HPB23-0575
September 12, 2023

Staff Analysis

Proposed

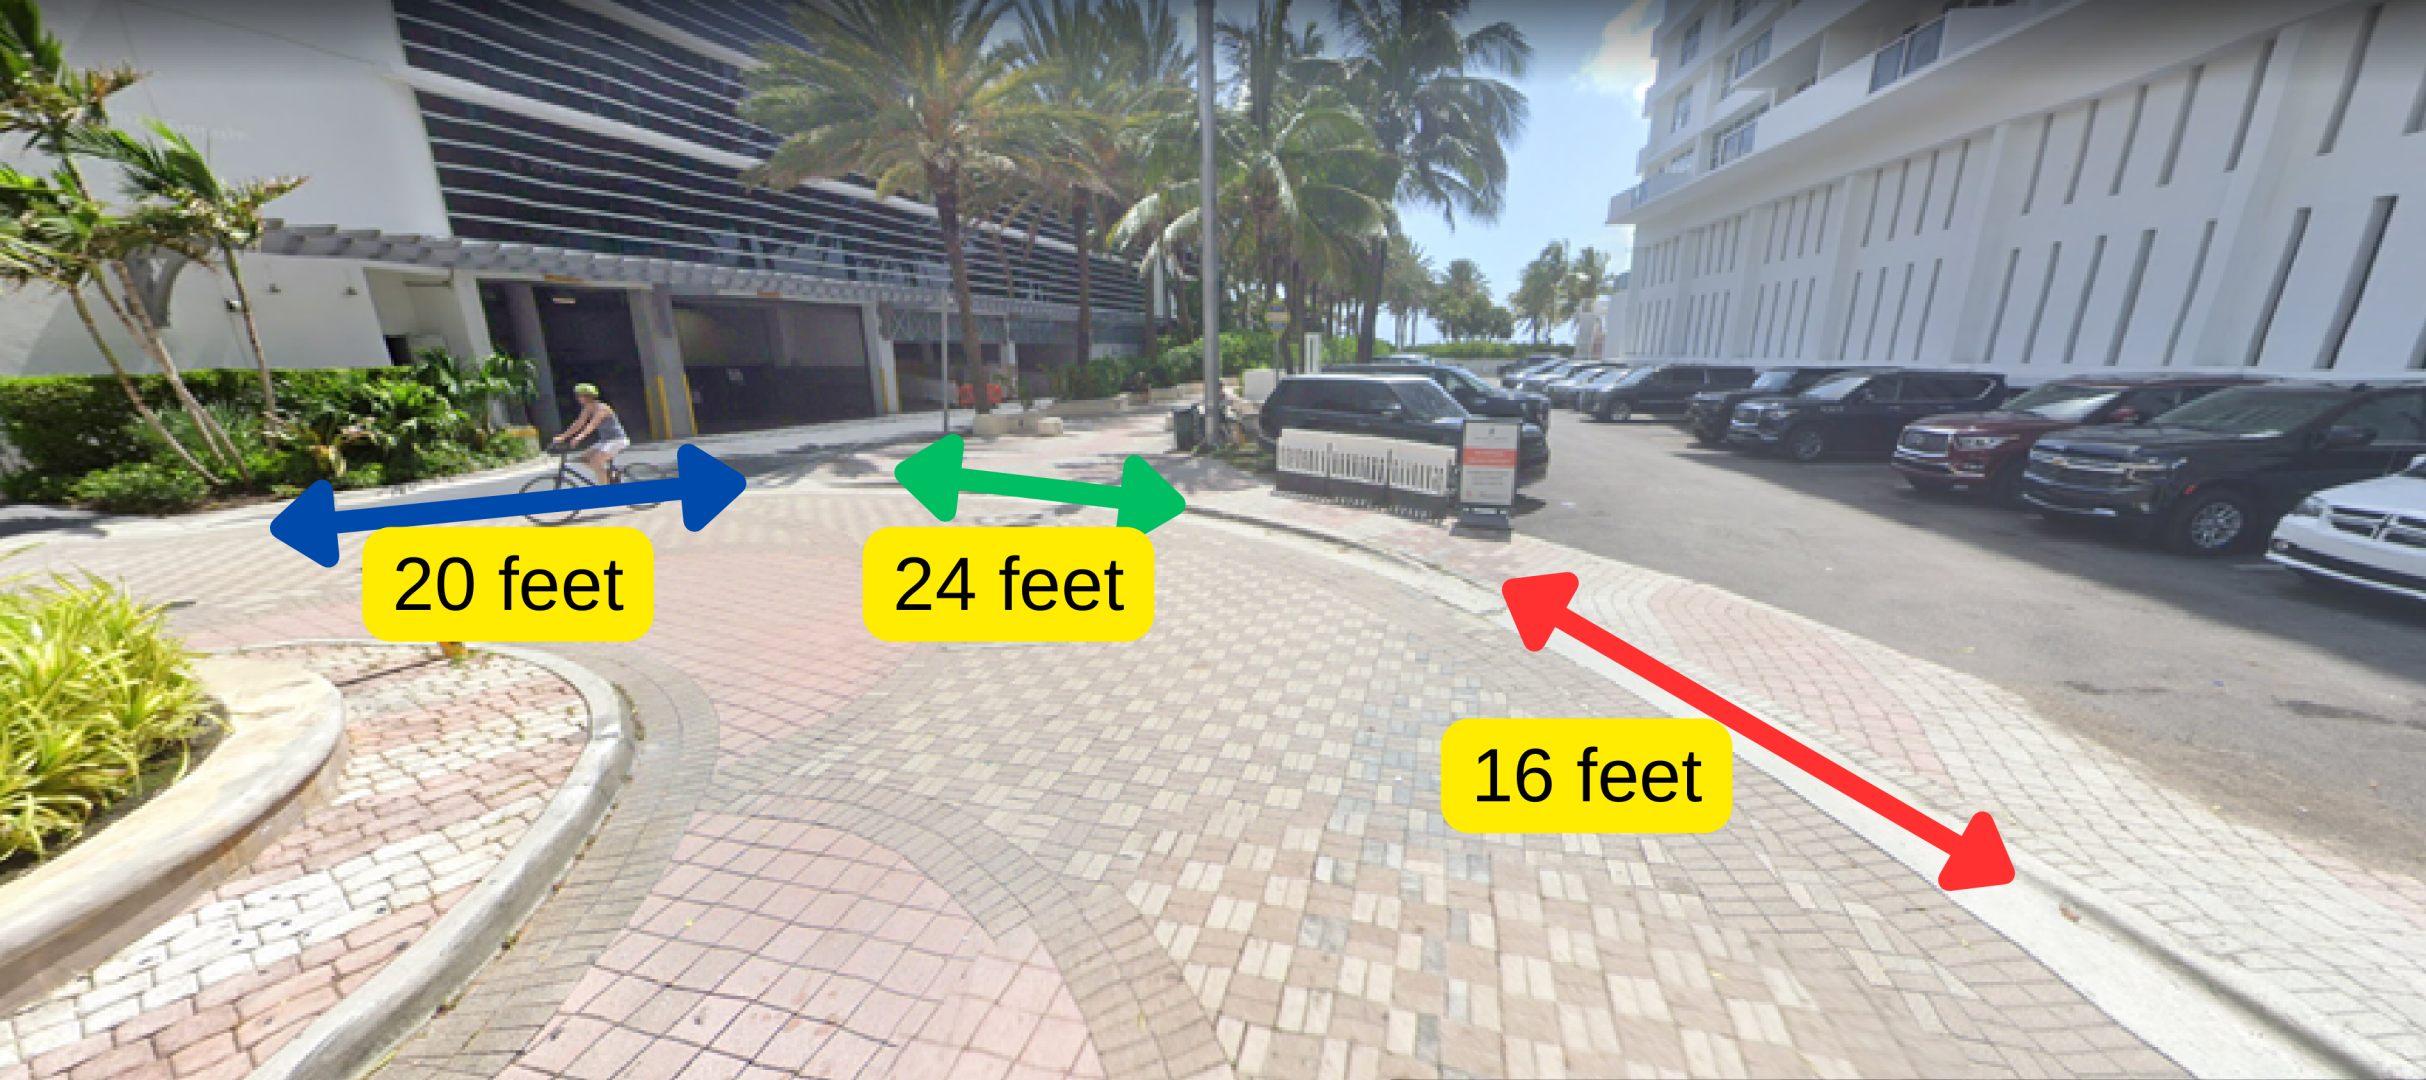
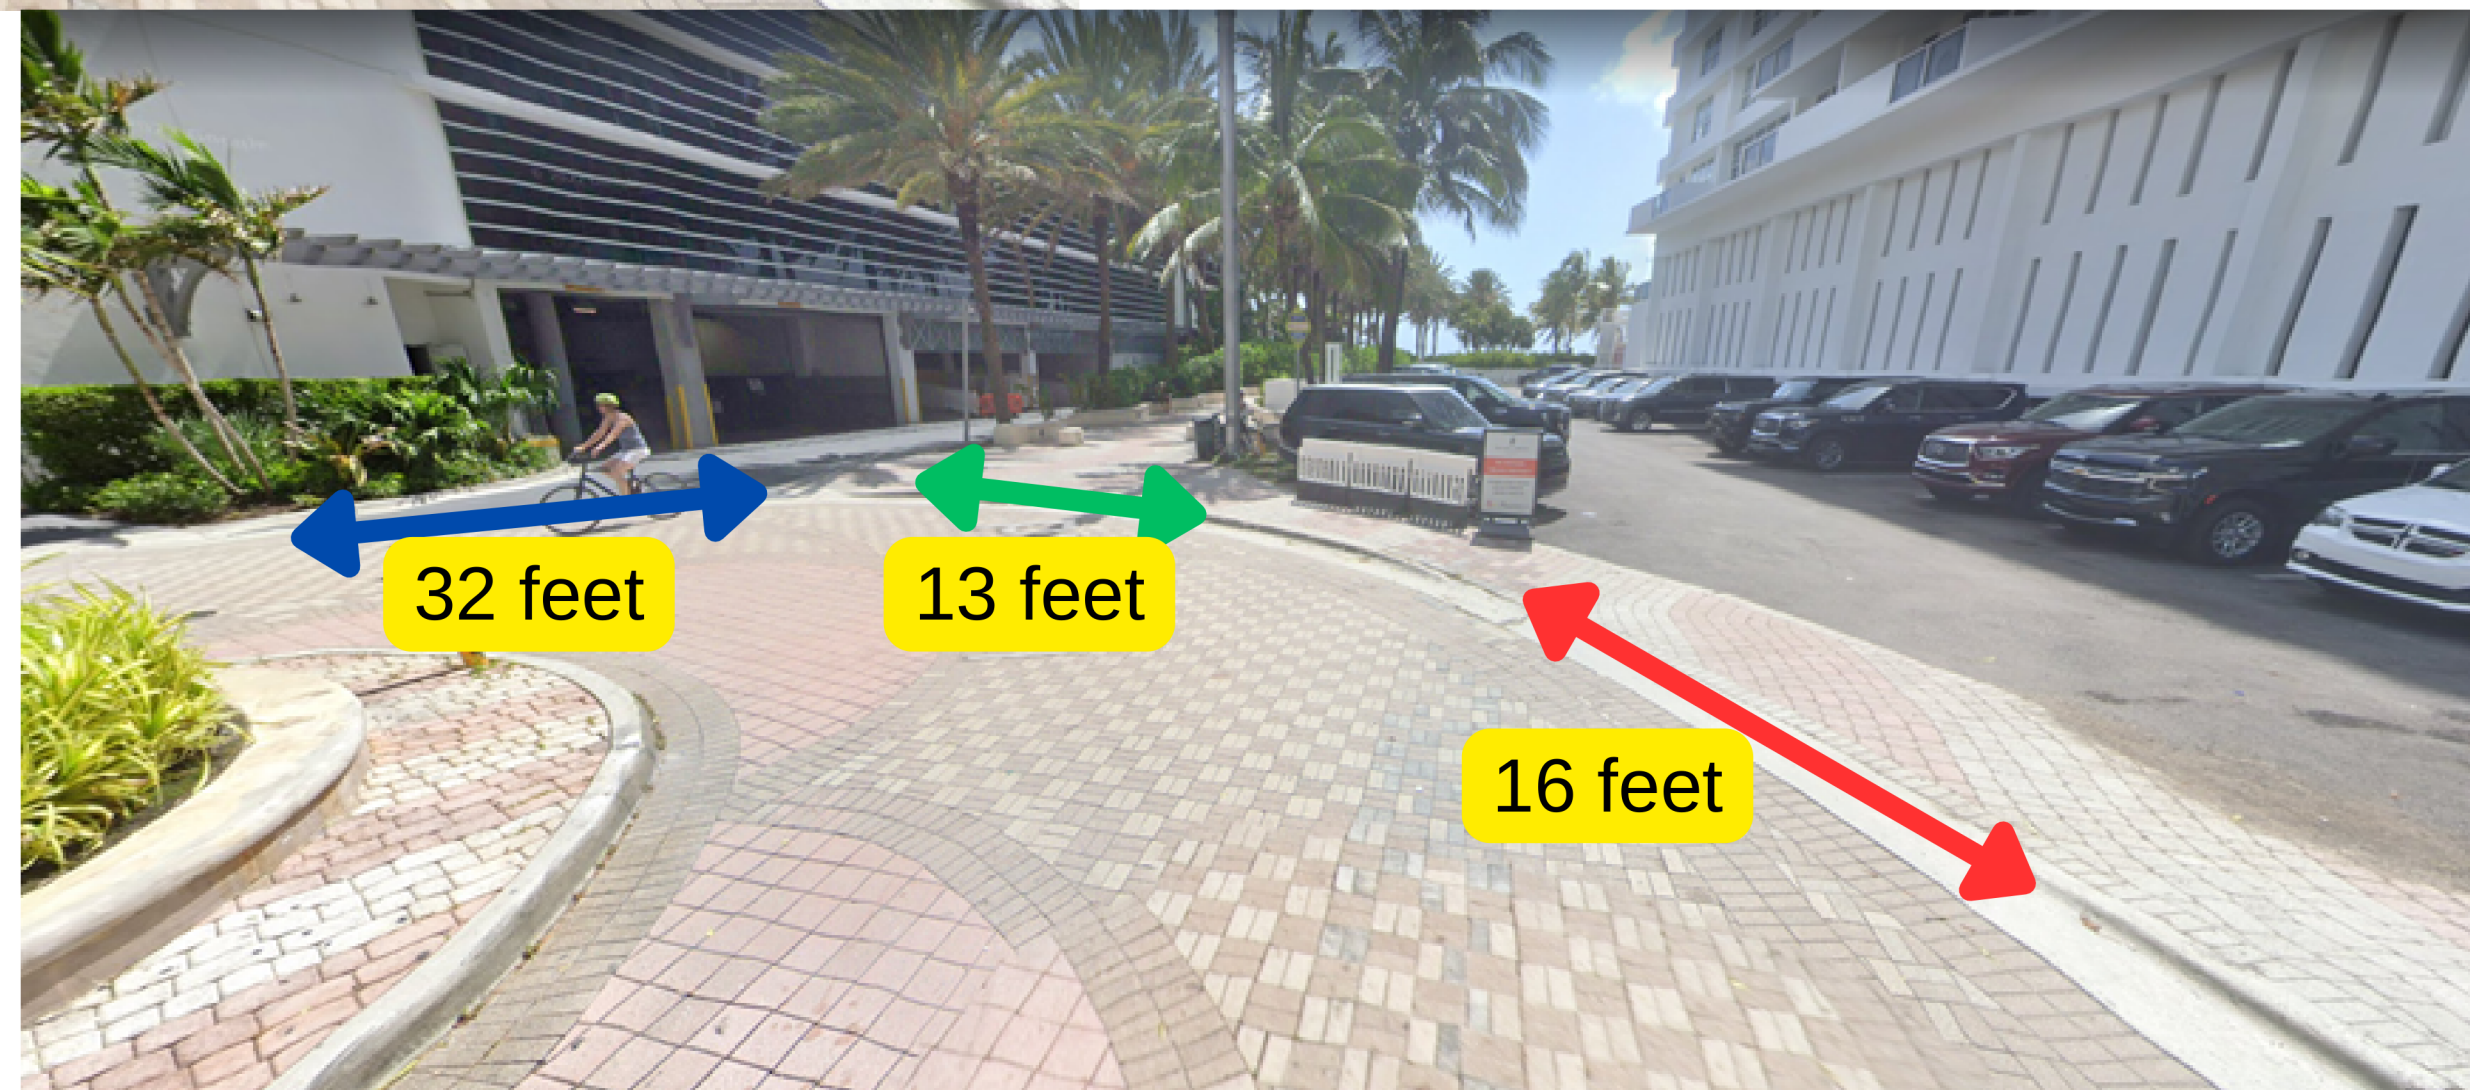
Loading Driveway width increases from 20' to 32'

Beach access path, at street end, decreases from approx. 24' to 13'

Direct applicant to work with stakeholders & staff to refine street-end design to be more appropriate and balanced than proposed

Maneuverability Analysis (SU40)

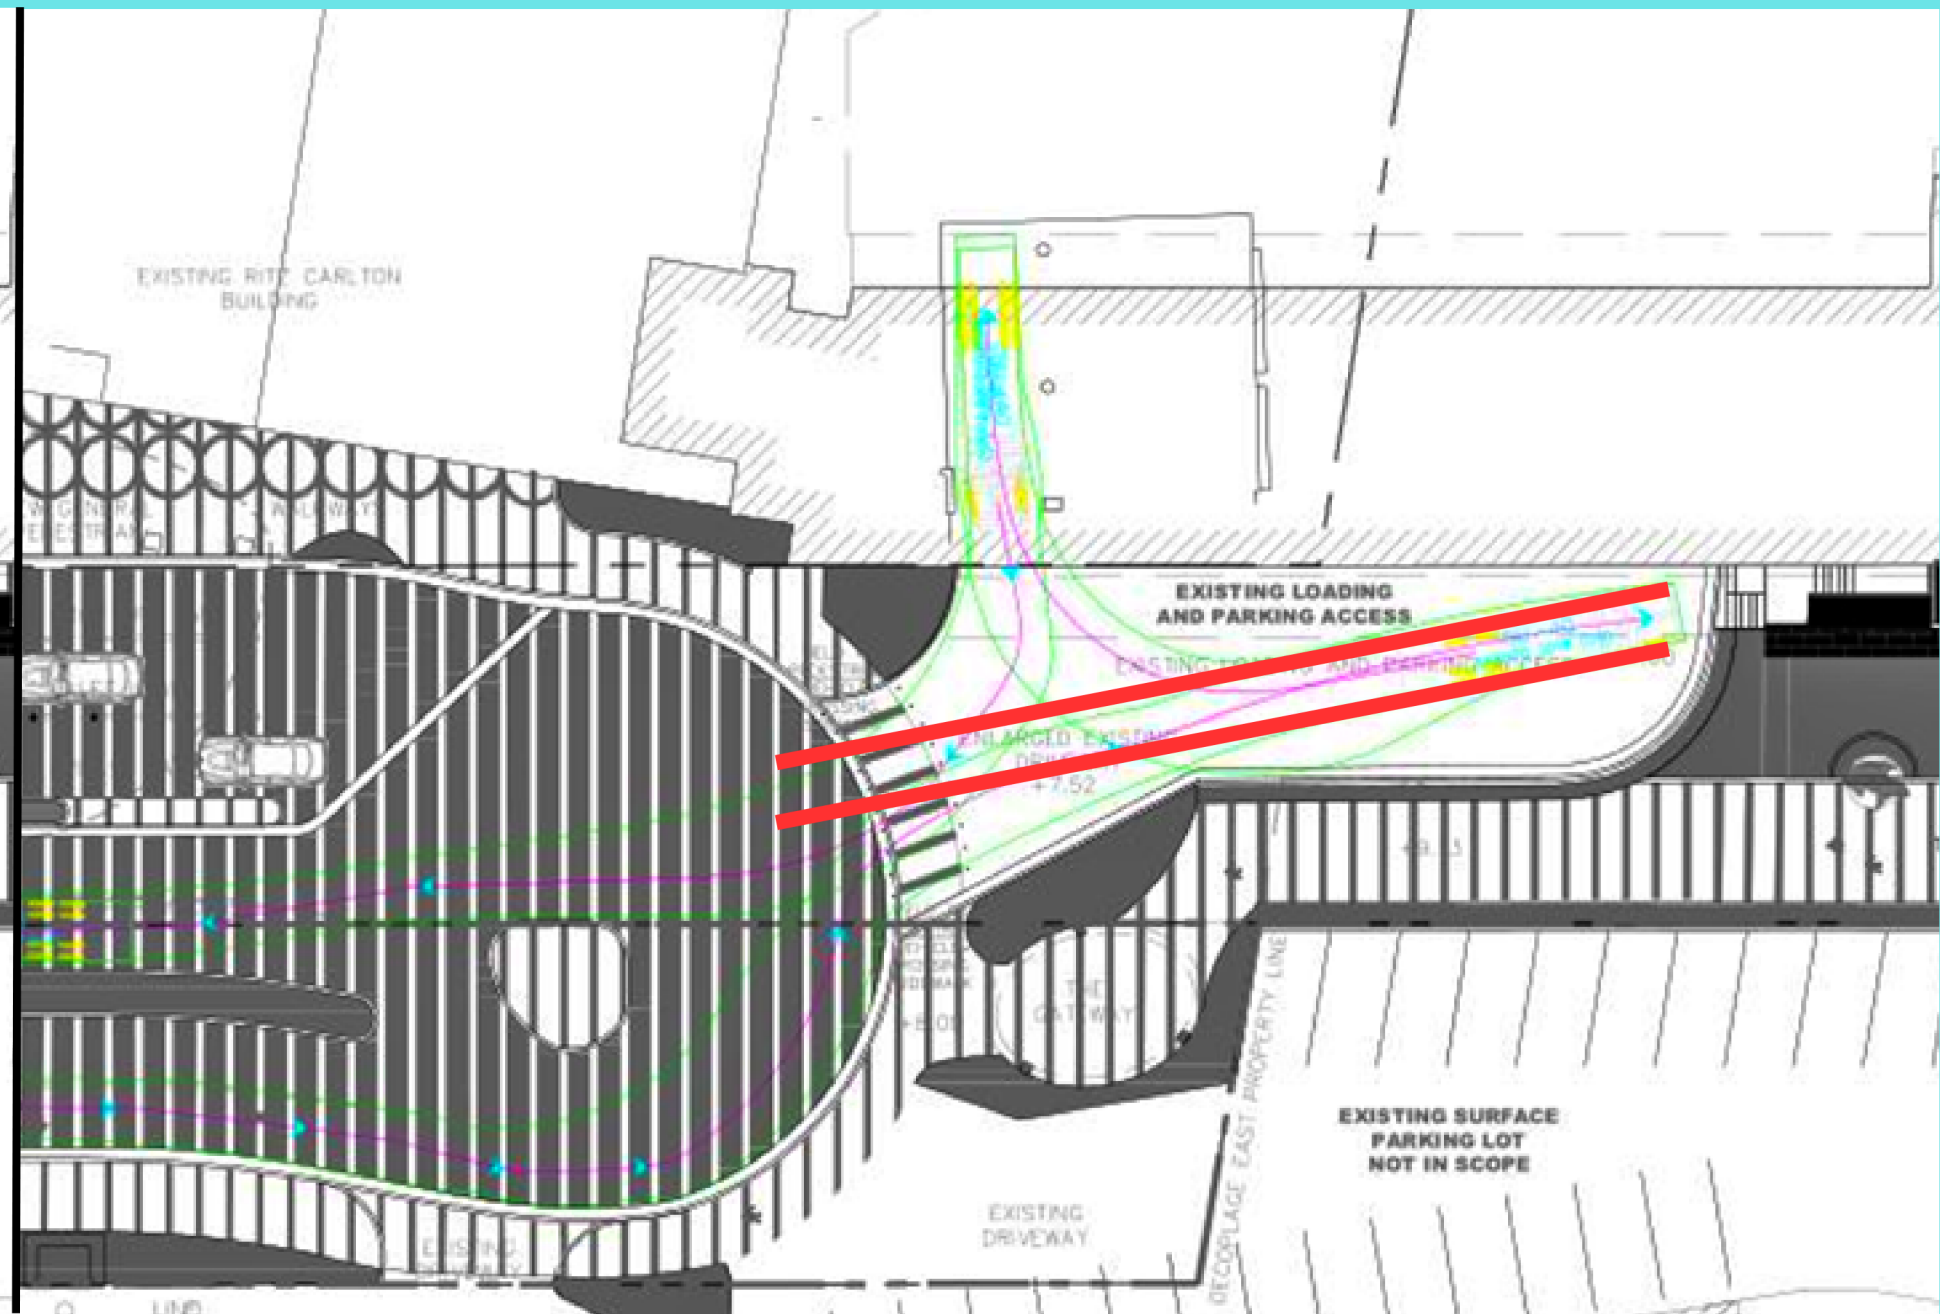
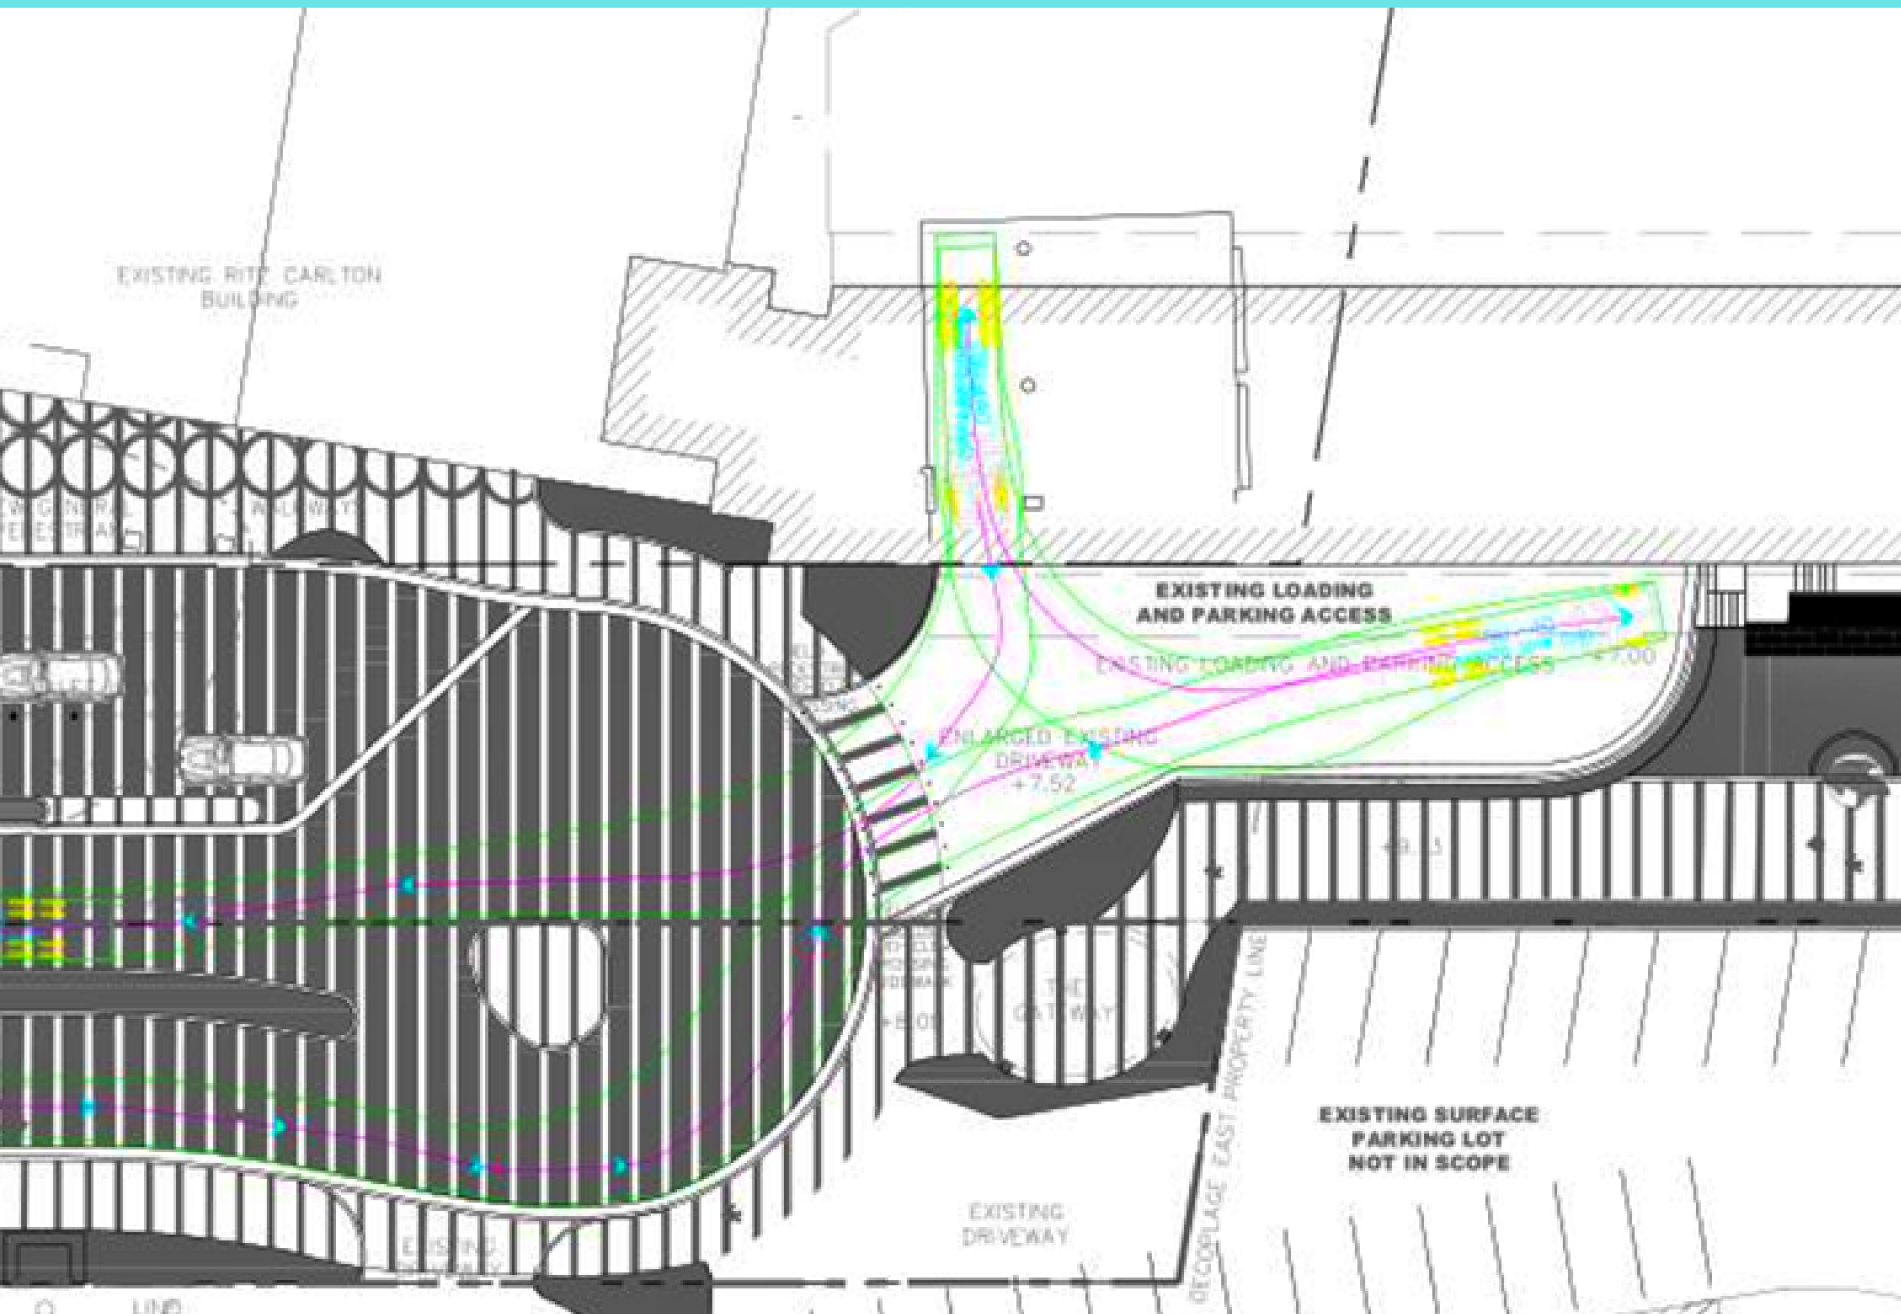
32 Feet (Proposed)

Less Than 32 Feet (Alternative)
